STRATEGY FOR RIIO-ED1

SUPPLEMENT TO THE NORTHERN POWERGRID RESPONSE TO THE

OFGEM CONSULTATION

ANSWERS TO QUESTIONS RAISED BY OFGEM

Figure 1: The yield on Northern Powergrid's traded debt relative to the iBoxx index

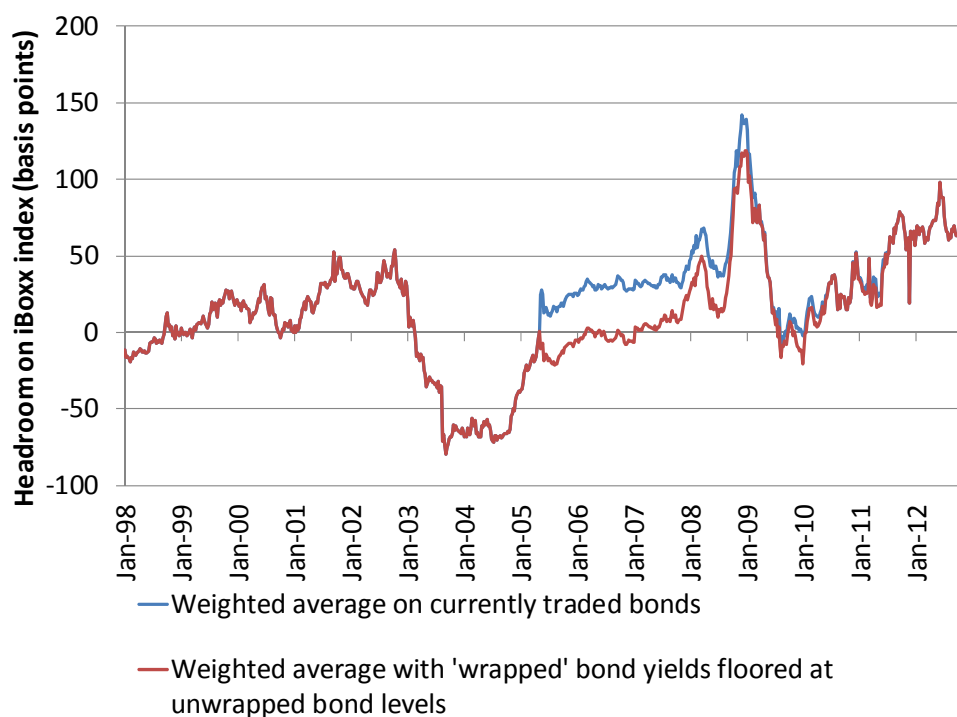
280. Our findings from the first of these pieces of analysis are shown in figure 1 below, adjusting for the fact that some of Northern Powergrid's debt benefits from a third party guarantee, which has been paid for in fees, and so has not always traded at yields that reflect the underlying credit strength of Northern Powergrid.
